Subject: Proposed Construction at Mt. Weather Emergency Operations Center

In Chapter 3 water resources are discussed.

Water Resources

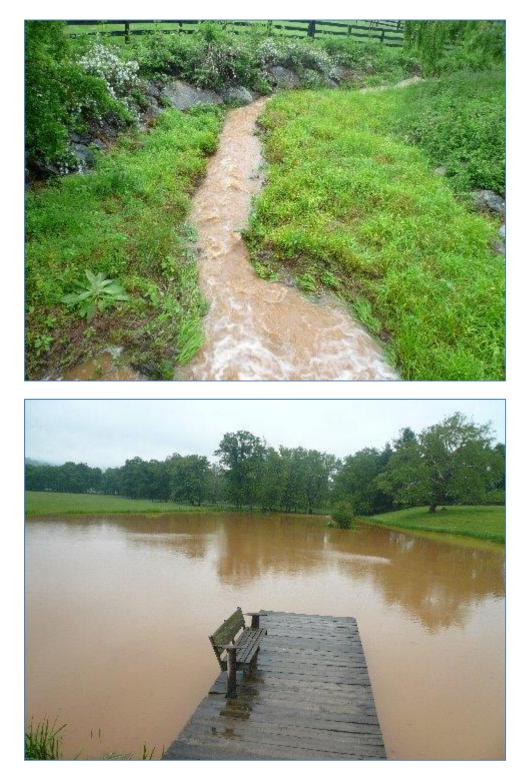
Development in the 900 Area will introduce additional impervious surfaces to the overall MWEOC campus, but is not expected to alter drainage patterns. Stormwater runoff from the 900 Area will continue to flow westward towards the existing retention basin, which functions as a way for stormwater to percolate into groundwater resources. In terms of the overall MWEOC, as older buildings are replaced with newer ones, the new buildings will reduce the overall amount of impervious surfaces from pavements and rooftops by increasing the amount of under roof square footage. In addition, sustainable design features would be included, such as rain water reclamation. These sustainable design features that address stormwater runoff would also apply to facilities developed within the 900 Area, as well as to the Proposed Action (see Section 2.1.2).

Due to the stormwater and wastewater management measures throughout MWEOC, the Proposed Action along with other foreseeable developments will not cumulatively affect groundwater supply and quality. Roadway runoff can contain vehicle fluids (gasoline and motor oil) and heavy metals, as well as surplus nutrients from fertilizer used throughout the campus for landscape maintenance. However, greater use of sustainable designs and retention basins, which will be part of future developments in MWEOC, will help to filter pollutants from runoff before discharging into groundwater. These measures will maintain the quality of the groundwater resource.

In short our comment is that we believe the construction activities at MWEOC must meet and exceed all stormwater management practices for both design and sediment control during construction and that measures be taken, especially during construction phase, to ensure that muddy waters not flow down from the site to Jeffries Branch. We hope that MWEOC staff has learned from the events on July 2009 and will avoid making similar mistakes.

In 2012 a Category 5a was assigned to Jeffries Branch

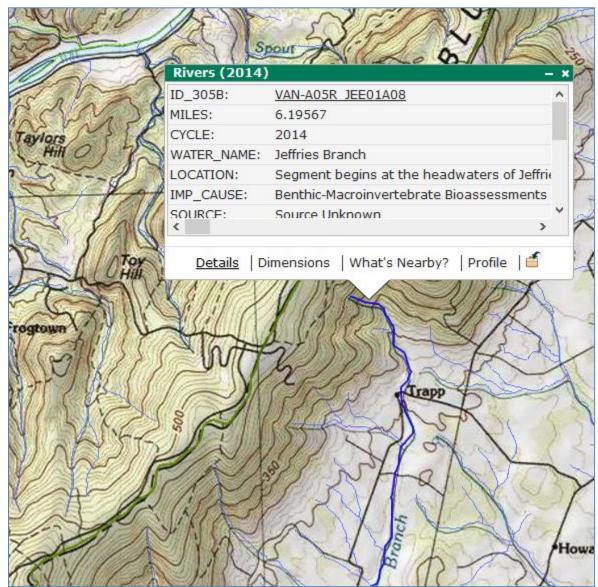
On June 8, 2009 the below images in and around Jeffries Branch downstream of Mt Weather were provided by members of Goose Creek Association. The soil erosion from Mount Weather was very heavy. The photographs show the muddy stream that feeds into Jeffries Branch and one of two ponds that is on Jeffries Branch. The huge bare ground on Mount Weather is clearly visible and it is the likely cause of the silting.

This sediment pollution lead to Virginia designation of a legal stream impairment. It was after Loudoun Watershed Watch and others requested VA Dept of Environmental Quality to monitor the stream that lead to a

stream impairment for aquatic life use. This means the poor benthic bugs in the streams were most likely impacted because of excessive sediment caused by stormwater abuse on Mt Weather in 2009.

<u>http://www.deq.virginia.gov/FS2014/FactSheets.aspx?id=VAN-A05R_JEE01A08&style=1</u> which states: 'Four biological monitoring events (2010-2011) at station 1aJEE002.22, at Route 743, resulted in a VSCI score indicating an impaired macroinvertebrate community."
